UNCC Health and Wellness Center
Addendum 3

July 3, 2017

Health and Wellness Center

**LAYOUT PLAN-
BASE BID**

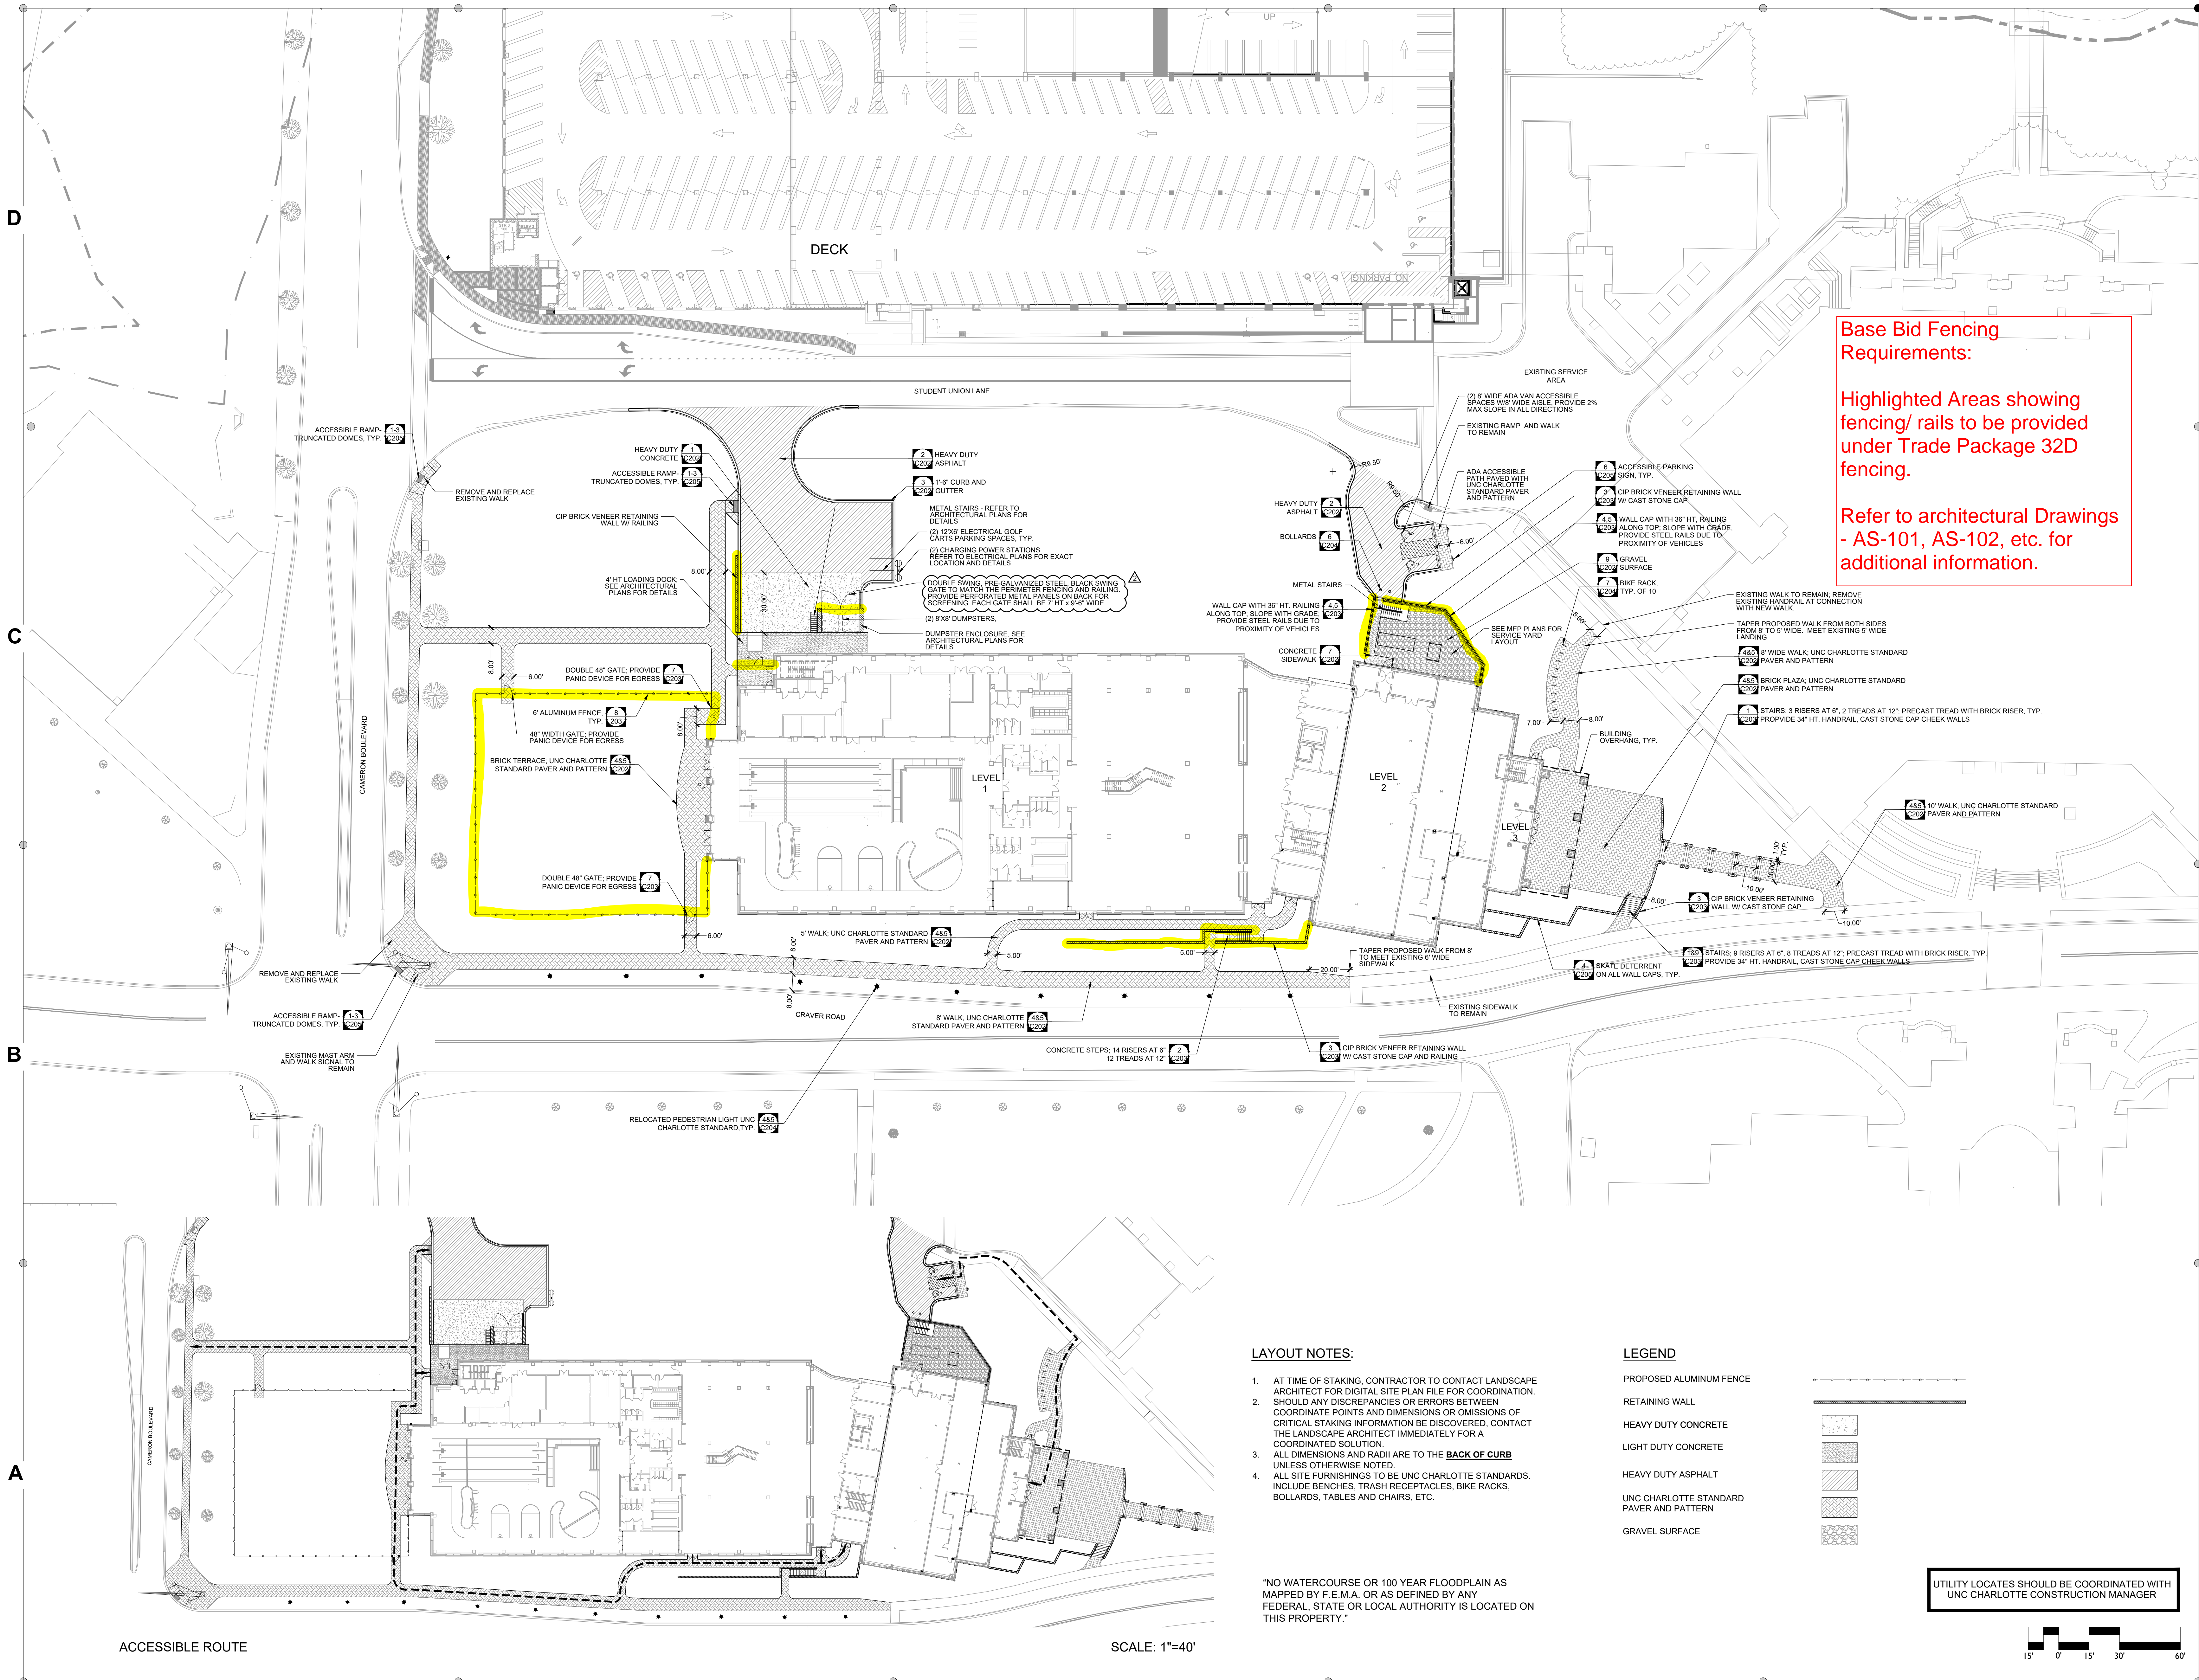
Base Bid Fencing Requirements:

Highlighted Areas showing fencing/ rails to be provided under Trade Package 32D fencing.

Refer to architectural Drawings - AS-101, AS-102, etc. for additional information.

**LAYOUT PLAN-
ALTERNATES 1, 2
AND 9**

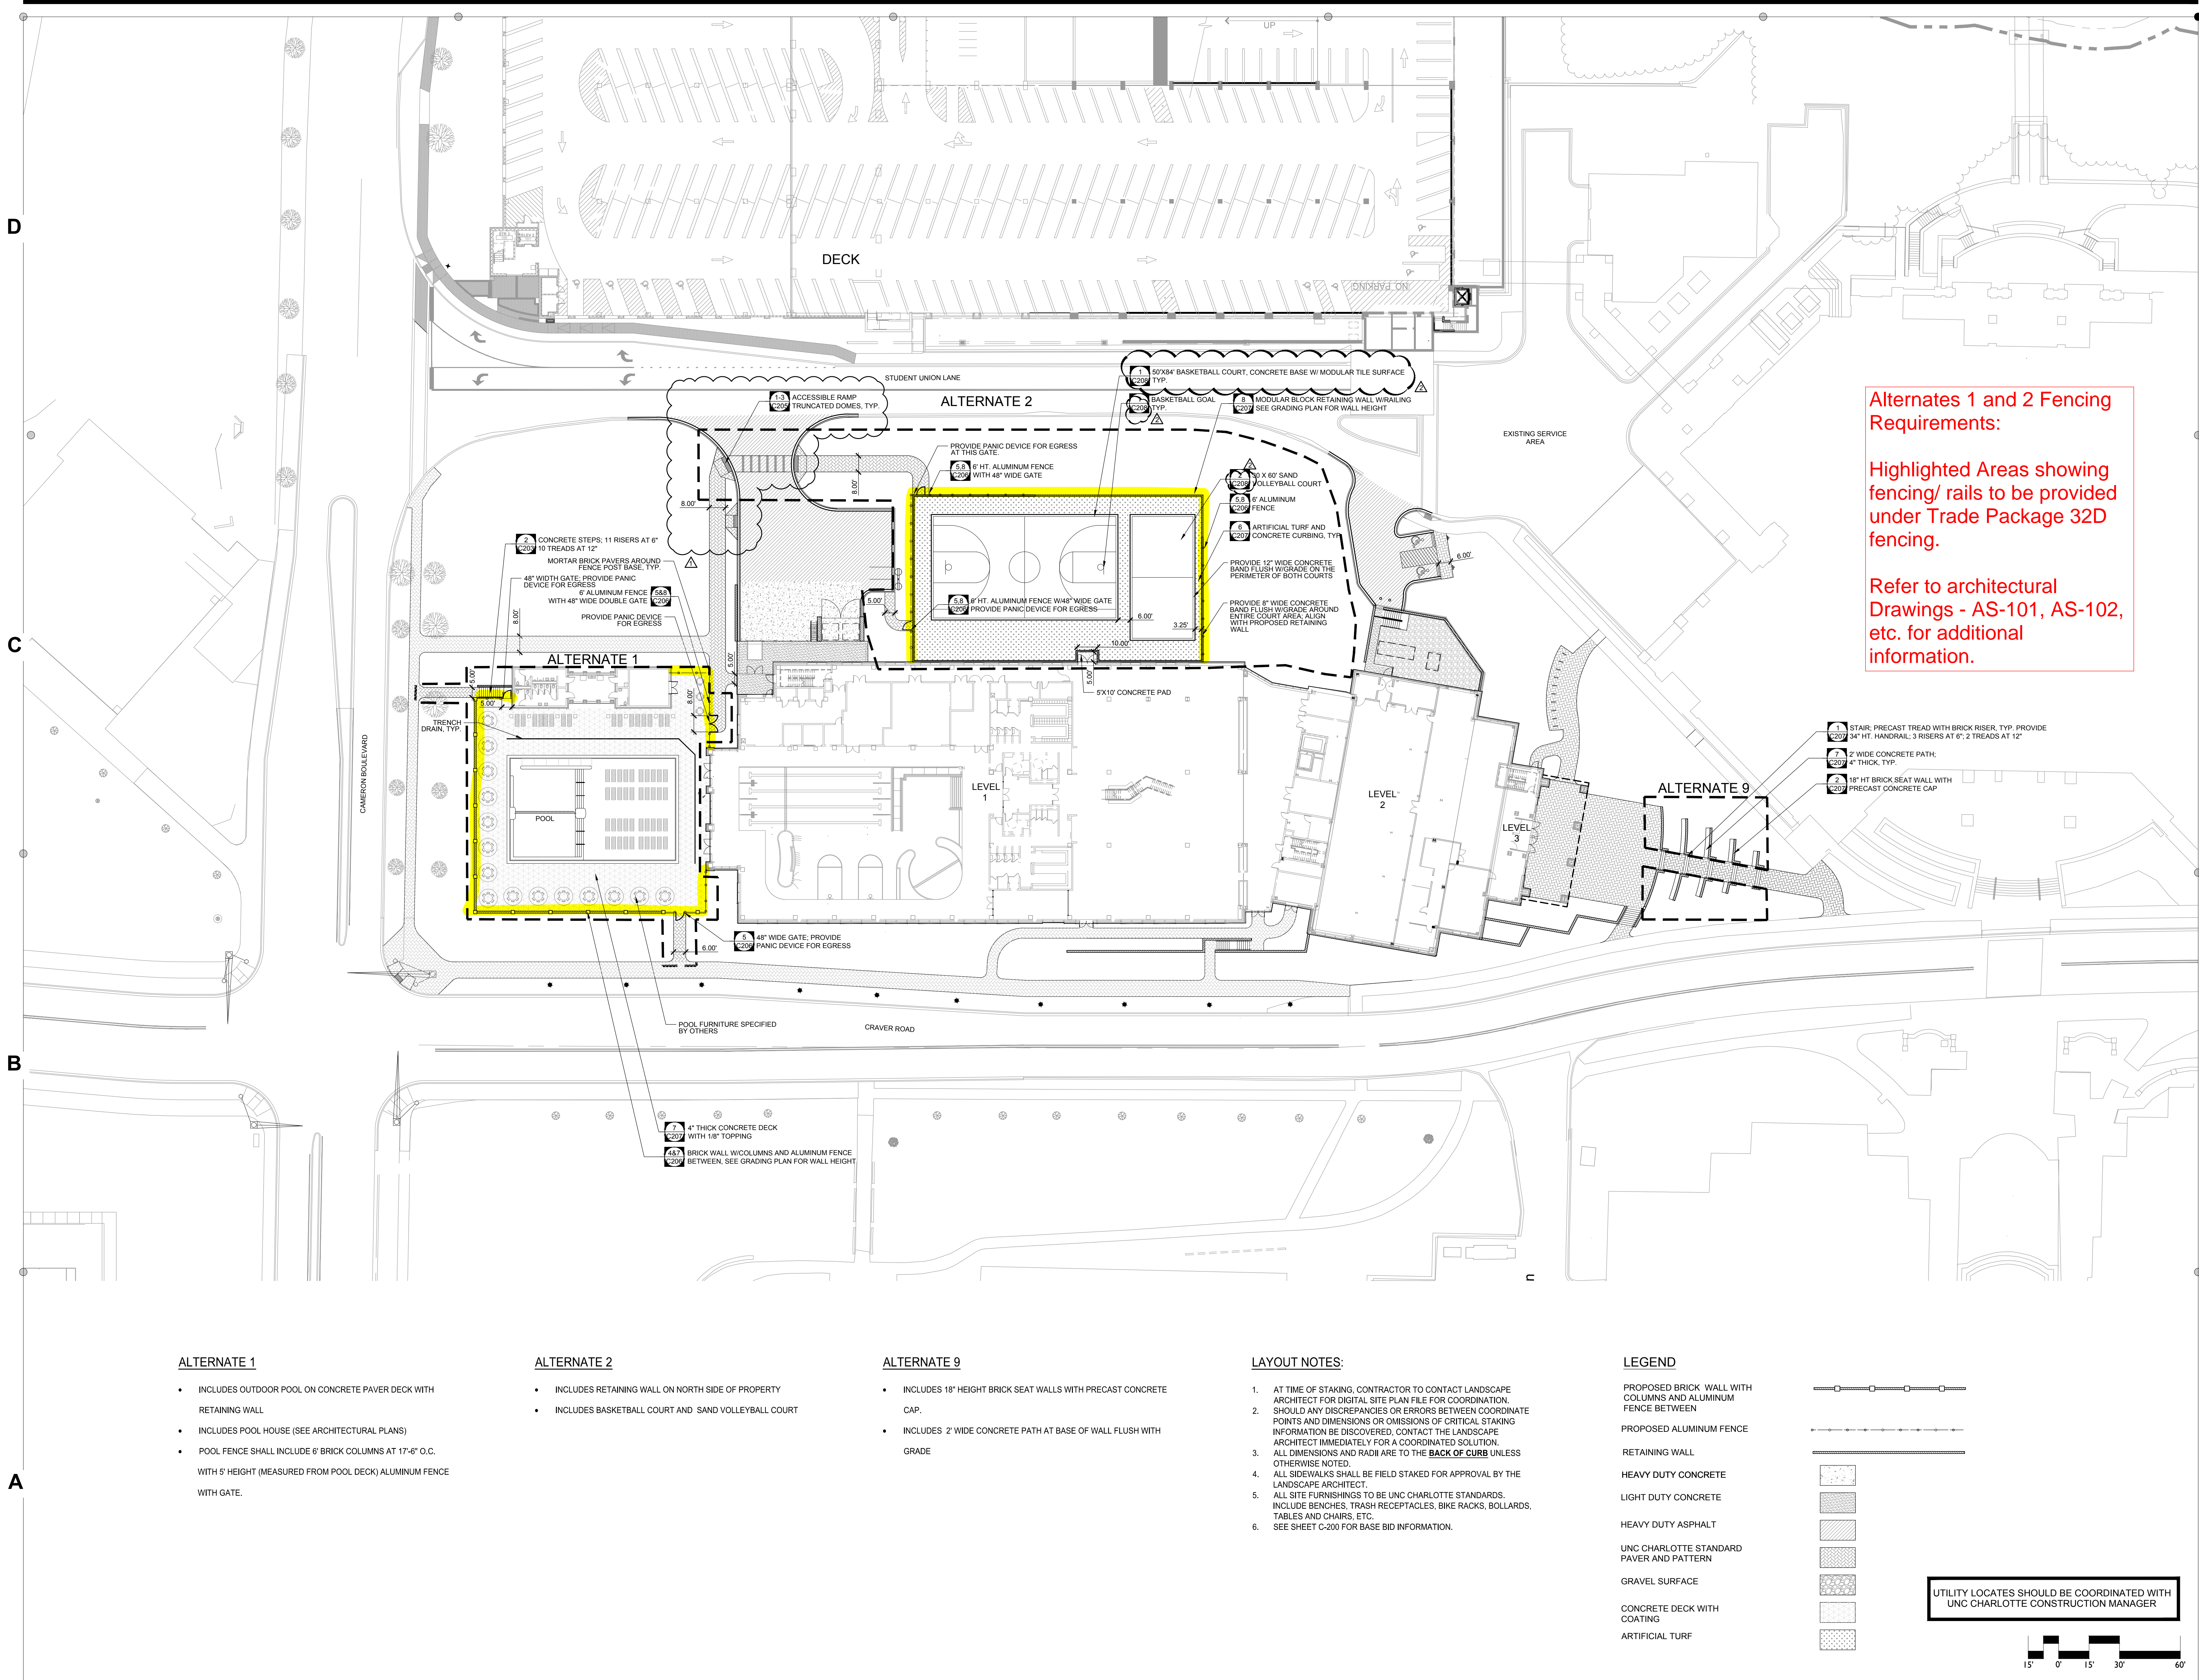
Alternates 1 and 2 Fencing Requirements:
Highlighted Areas showing fencing/ rails to be provided under Trade Package 32D fencing.
Refer to architectural Drawings - AS-101, AS-102, etc. for additional information.
